RENESAS TECHNICAL UPDATE

Product Category	MPU/MCU		Document No.	TN-H8*-A426A/E	Rev.	1.00
Title	Additional Usage Notes on Interrupts		Information Category	Technical Notification		
Applicable Product	H8SX Group	Lot No.	Reference Document	Refer to the "Reference Documents" section below		
		All lots

We would like to inform you of additional usage notes in the description about the interrupt controller in the H8SX Group Hardware Manual. Please read these additional notes carefully before using the H8SX Group products.

Figure 1 Interrupt Masking Procedure to Avoid Conflict between Interrupt Generation and Disabling

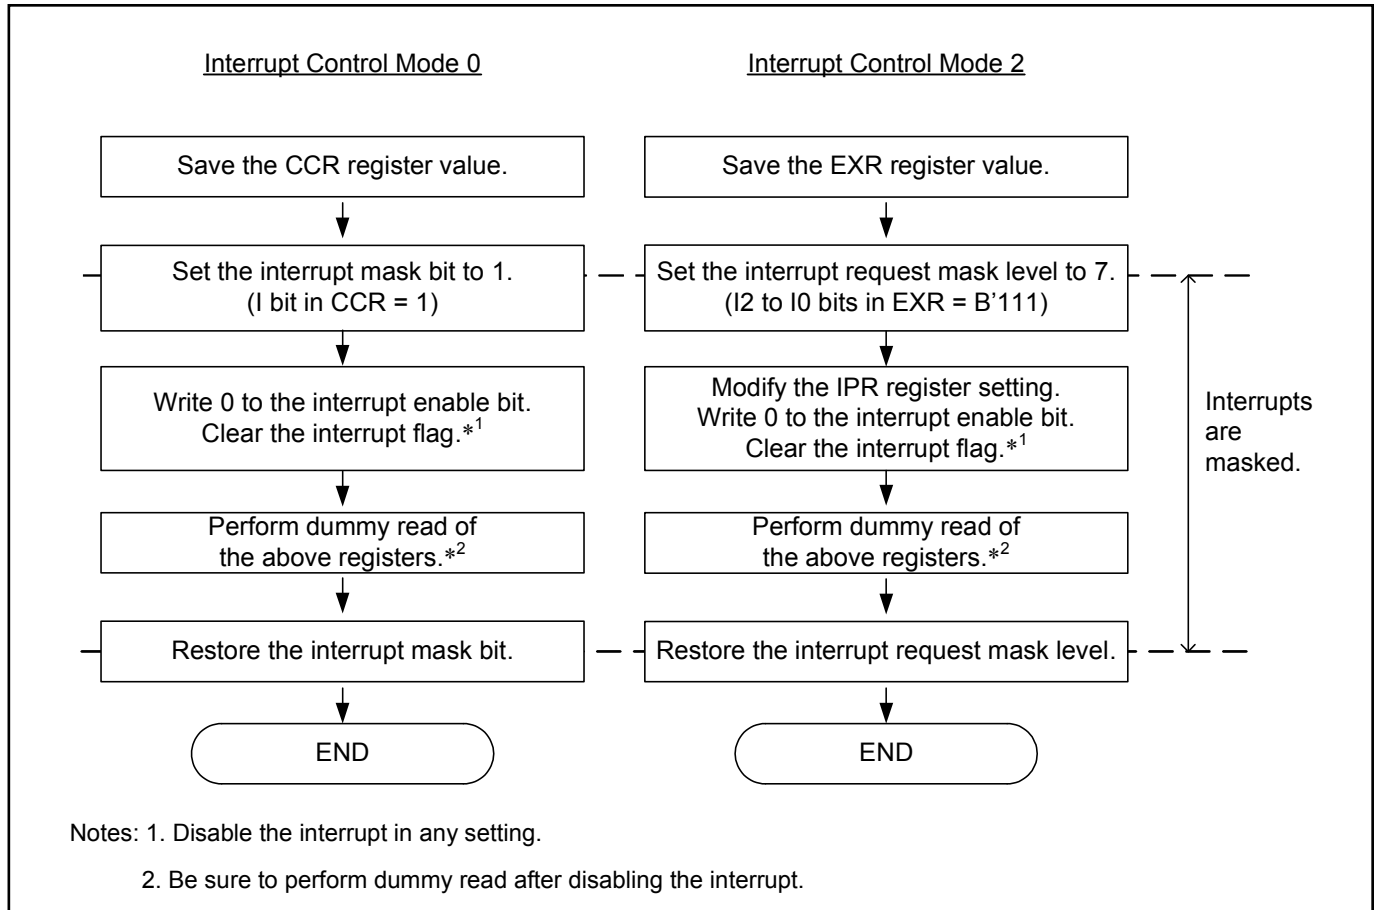
If this conflict occurs in interrupt control mode 2, the interrupt exception handling with priority equal to or lower than the interrupt mask level (I2 to I0 setting in EXR) may be executed on completion of the interrupt disabling instruction.

In addition, note that the interrupt priority register (IPR) may generate this conflict.

When a conflict between interrupt generation and disabling may occur in your system, avoid it by masking interrupts as shown in figure 1. There is no additional note about interrupt control mode 0, but if a conflict may occur in this mode, it should also be avoided through the procedure shown in figure 1.

Figure 7.8 shows the interrupt masking procedure to avoid this conflict.

Same as figure 1 in this technical update.

Figure 7.8 Procedure for Avoiding Interrupt Conflict
